5TH AND VIRGINIA

Proposed MUP #3018037

# SECTION 02. RESPONSE TO EDG

7(D) LIGHT & AIR IN ALLEY /

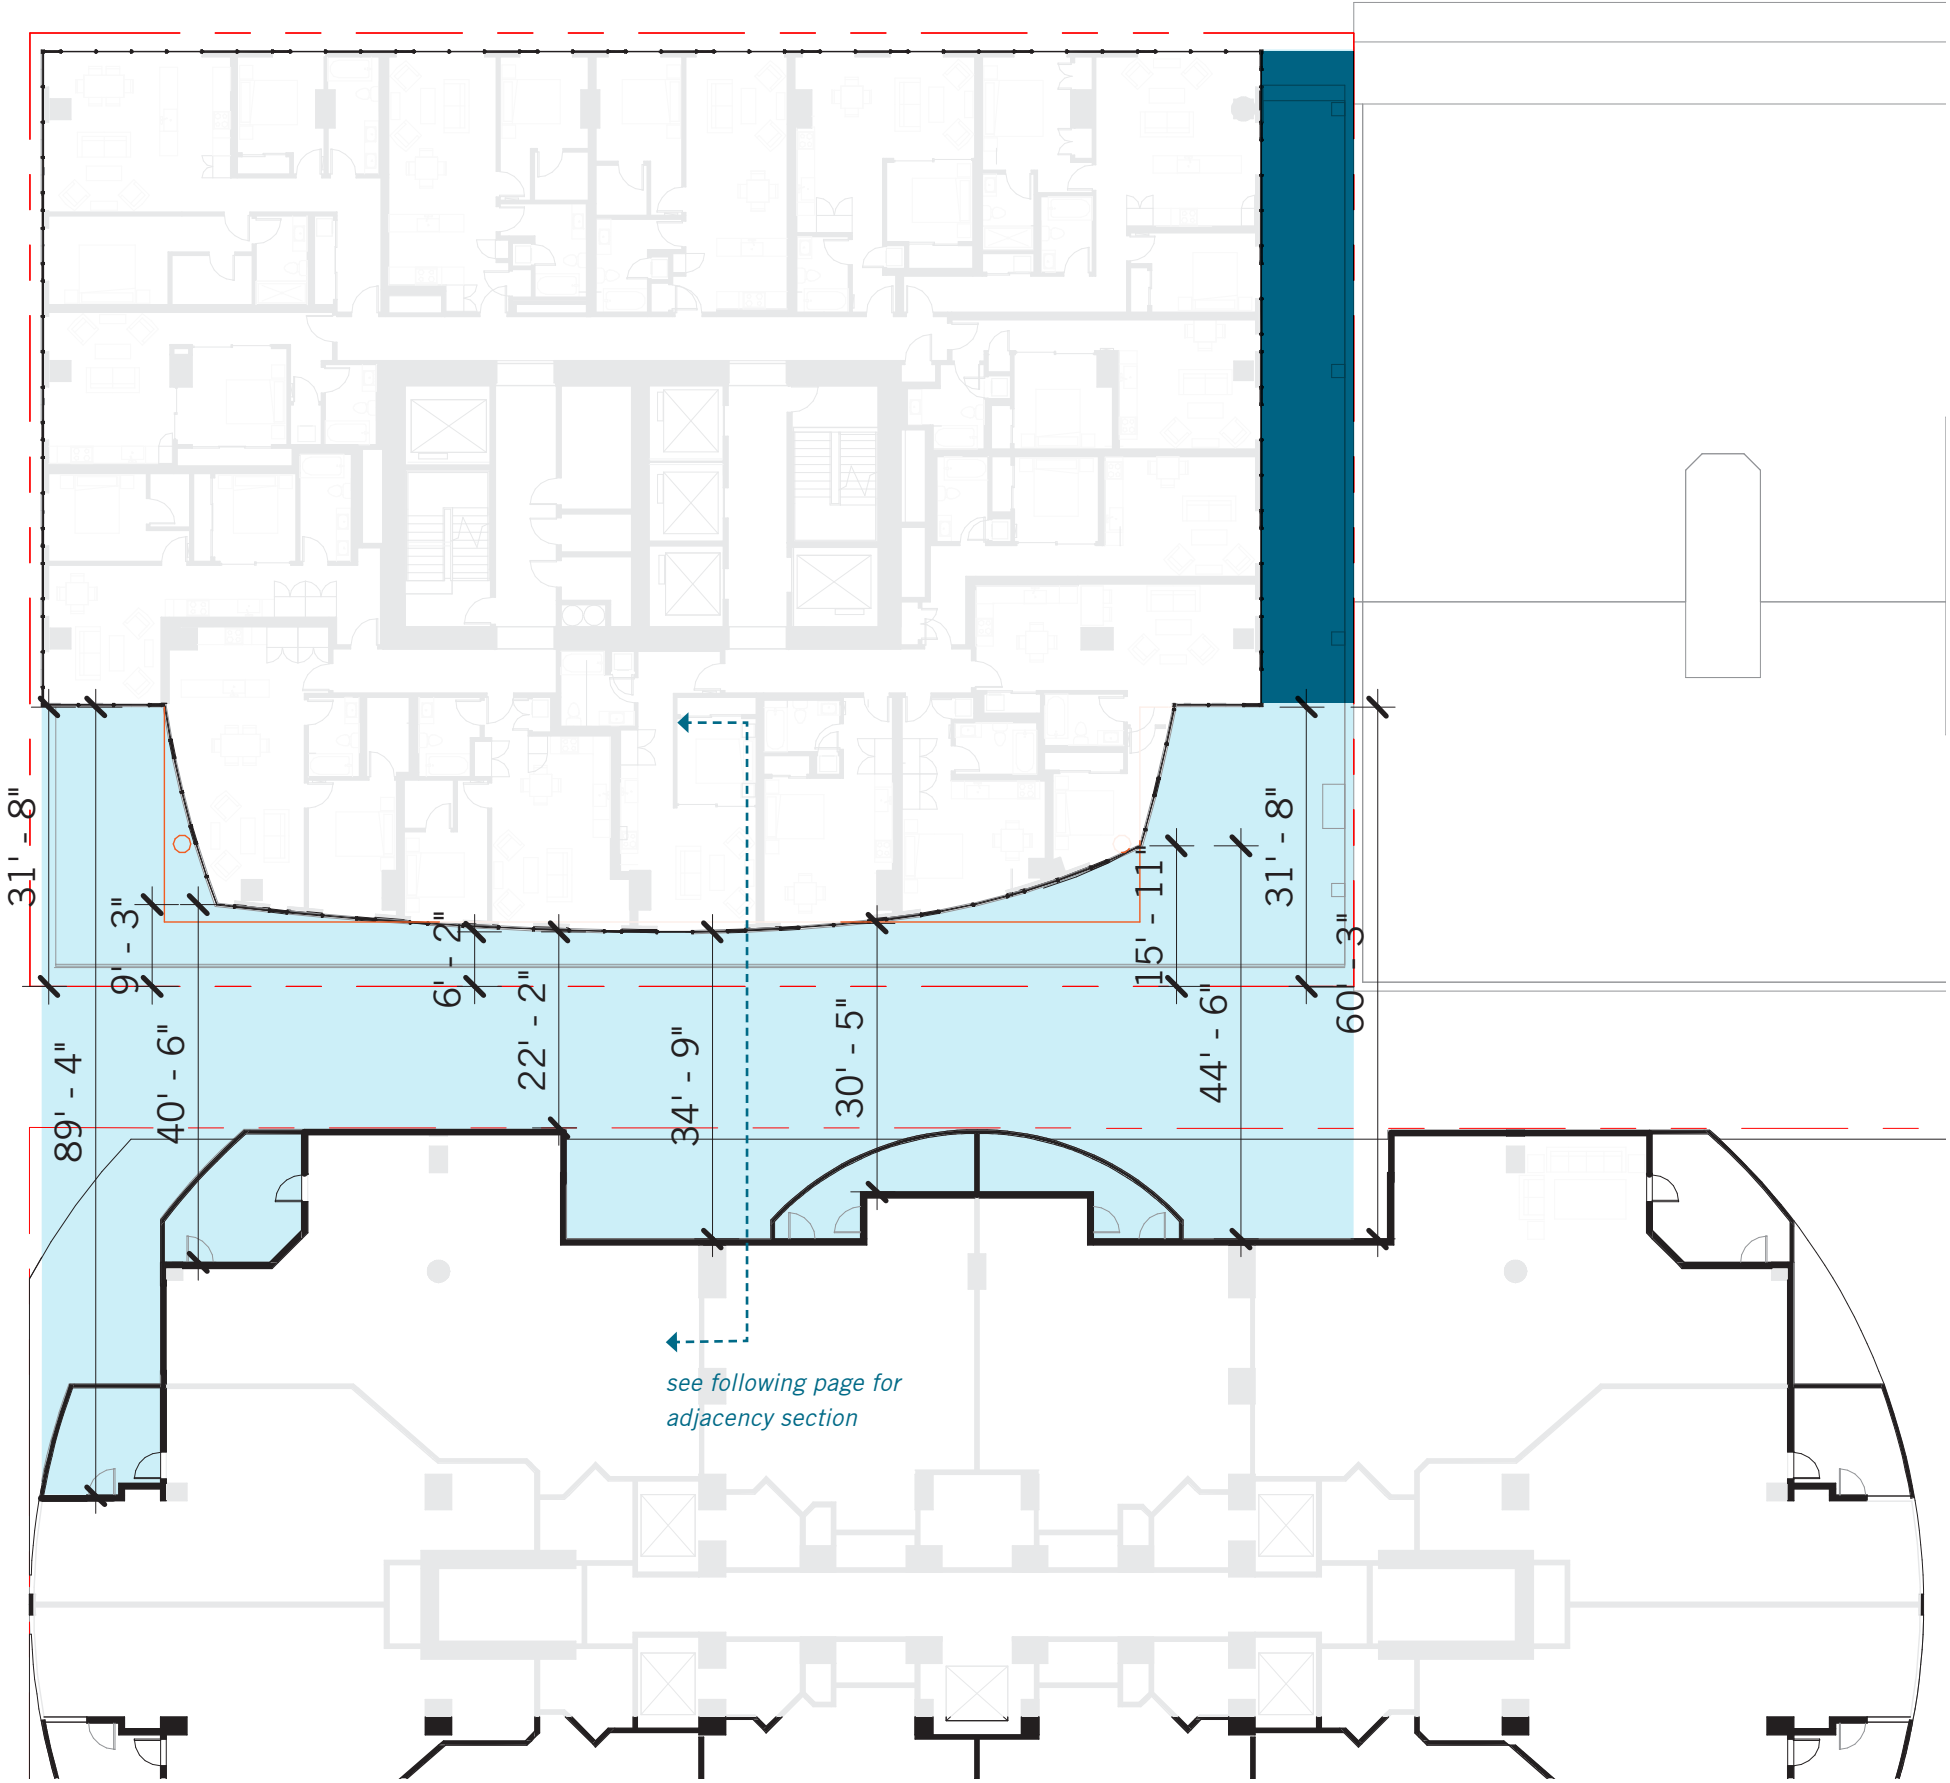
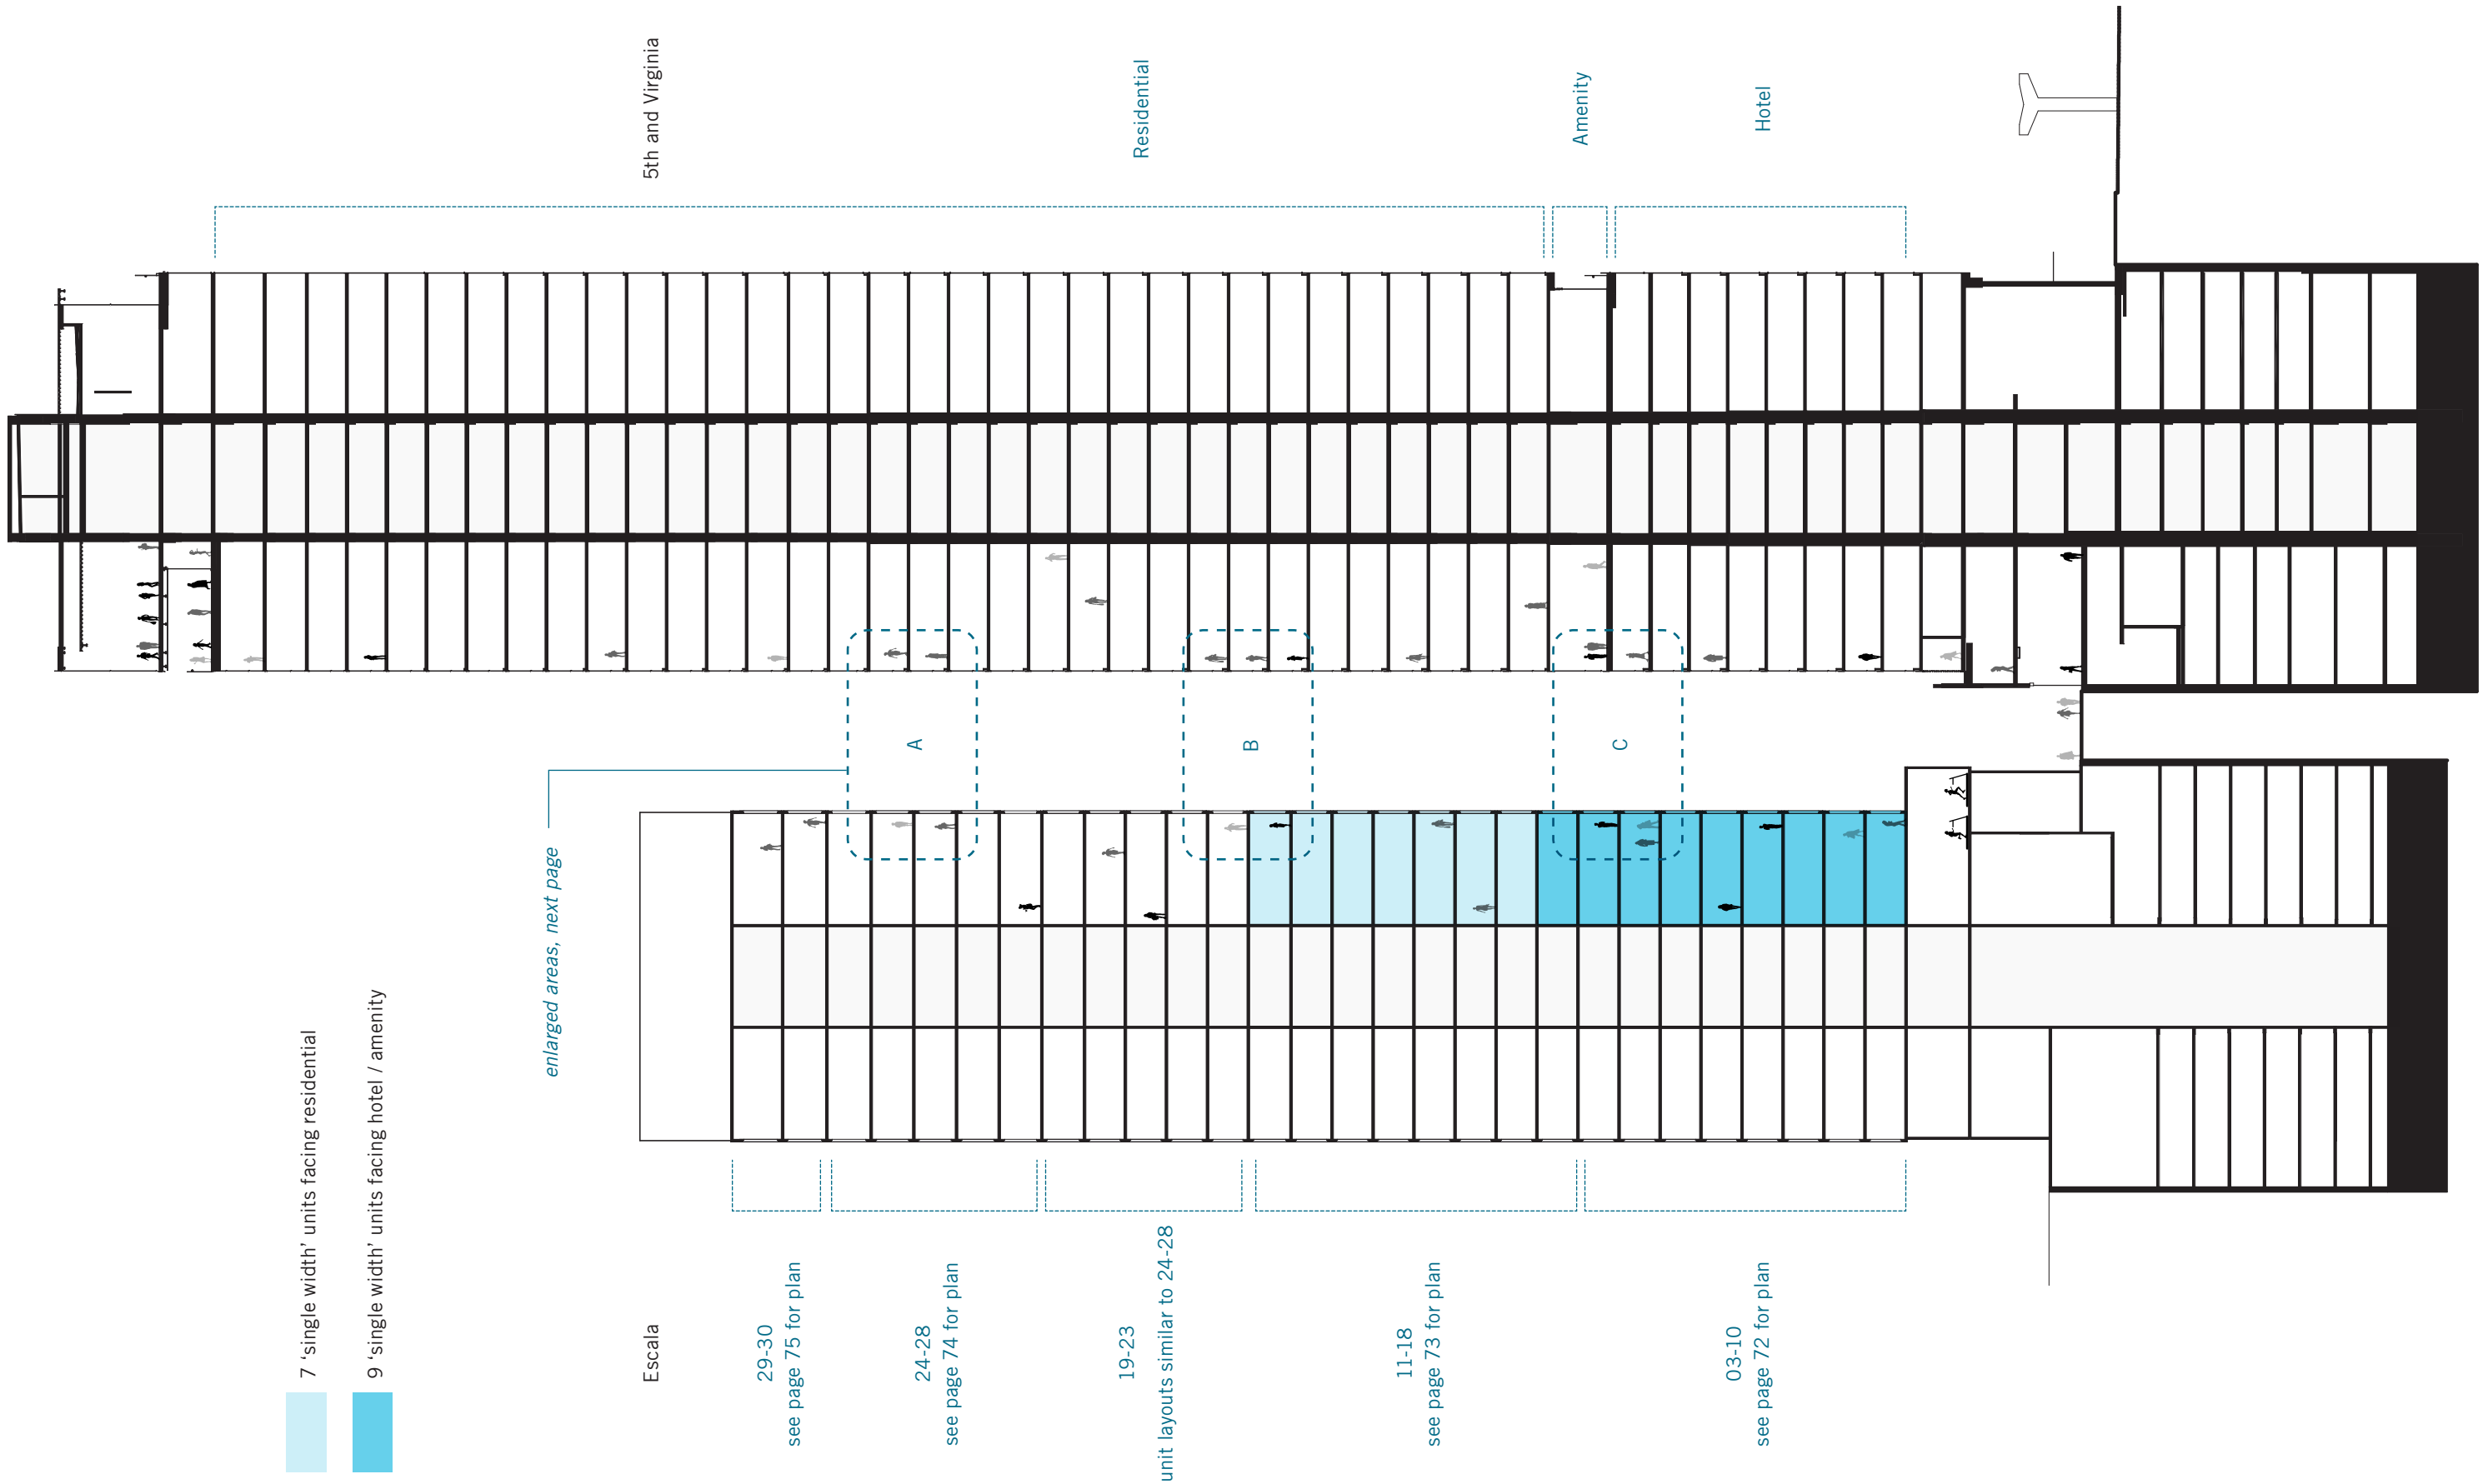
Whatever the final shape of the west wall (5d above), the Board strongly reiterated the guidance under EDG#1, item 2b, and further recommended the following to ensure reasonable privacy between the two buildings: First- the proposed hotel rooms and units at the west corners of the tower should have windows mostly - if not entirely- oriented to the south or north. Second - the west wall depth should be substantial (14-24” advised) to provide for canted windows and other techniques to ensure unit to unit privacy, especially between living rooms and at the central portions of floors 4-19, where corner re-orientation is not possible. Other techniques such as louvered privacy windows, one-way films, vertical slot windows, etc should also be considered. (B1.I)

The design has been substantially modified in response to DRB guidance to address adjacency concerns. Numerous significant changes have been made as follows:

- 6. Privacy shades will be provided at all west facing windows.
- 7. Interior layouts have been modified with special care taken to locate living spaces and window locations to minimize overlaps with living spaces in the neighboring building.
